MECKLENBURG COUNTY
DEPARTMENT OF ENVIRONMENTAL HEALTH

APPLICATION FOR SOIL INVESTIGATION

SITE INVESTIGATION REPORT
INDIVIDUAL SEPTIC TANK SYSTEM
WITH SUBSURFACE,
SOIL ABSORPTION,
EFFLUENT DISCHARGE

SUBJECT: Apt. #13755
Pamela Drive Lot 4 Block B

Project

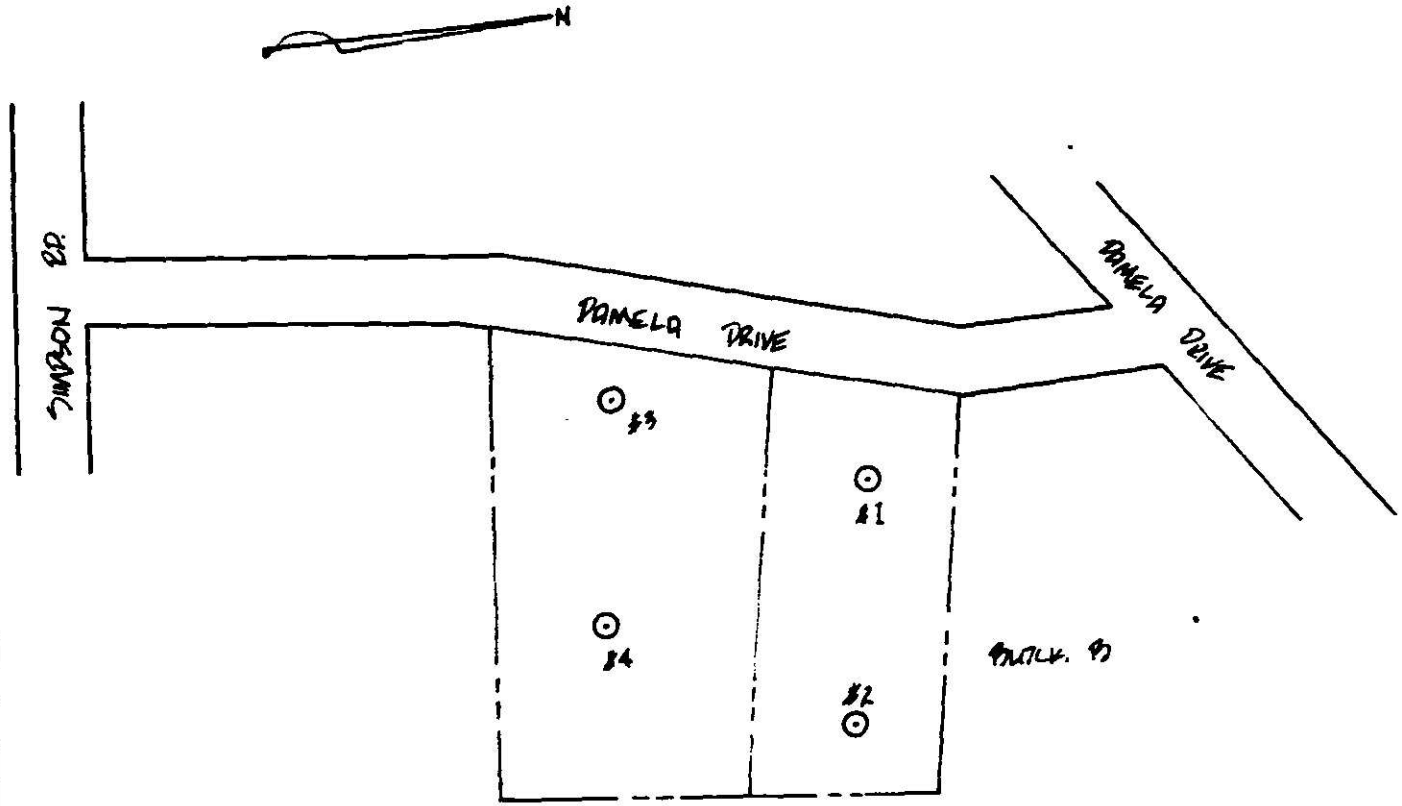
Soil Permeability: Four percolation tests were performed in the lots at the approximate locations shown on the attached plan. These tests were in the silt soils. The results of the tests taken 30 inches below grade follow:

Test Location	Soil Percolation Rate
Lot 4 - Test 3	10 minutes/inch
Lot 4 - Test 4	30 minutes/inch
Lot 5 - Test 1	45 minutes/inch
Lot 5 - Test 2	20 minutes/inch

Both lots are suitable for septic tank absorption fields provided that the bottom of the trench is no more than 2 feet below existing grade. This will provide a trench bottom one foot above the water table. This may require regrading the site to provide necessary ground cover.
